**TOWNSHIP OF ABINGTON**

**(2) CODE ENFORCEMENT AND LAND DEVELOPMENT COMMITTEE**

**CE1. Subdivision and Land Development LD-16-06 – Steven Kozlowski – 1235 Meinel Road**

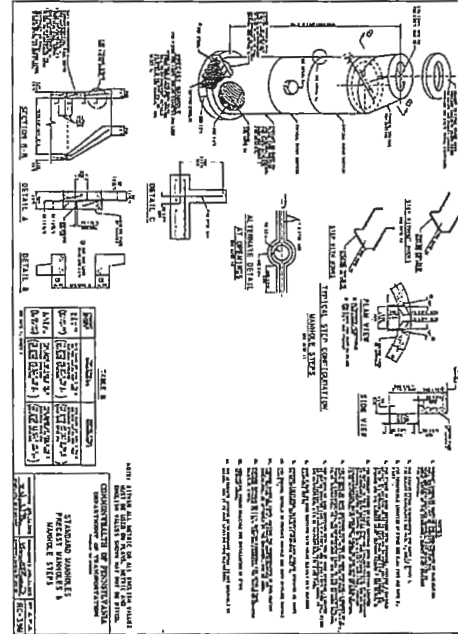
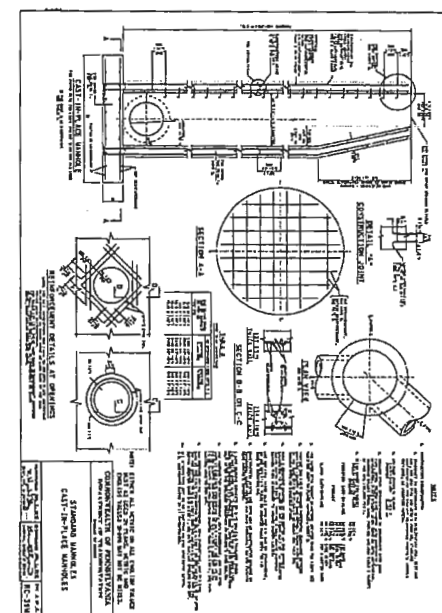
Sheet 14 of 17 – Site Details: The details "Type A Standard Manhole", "Water Crossings", "Utility Crossings", "Standard Manhole Frame and Cover" and "Sanitary Sewer Service Connection" should be replaced with the current Township of Abington Sanitary Sewer Details. (see enclosed) Proposed Details "Vent Pipe in Paving or Sidewalk Detail", "PVC Pipe Embedment" and "Concrete Encasement" should be omitted from the plans. Vent pipes proposed for asphalt surfaces shall conform to Detail No. 38 and be modified to use the "Clean-out Protection Sleeve" detail as indicated on this sheet.
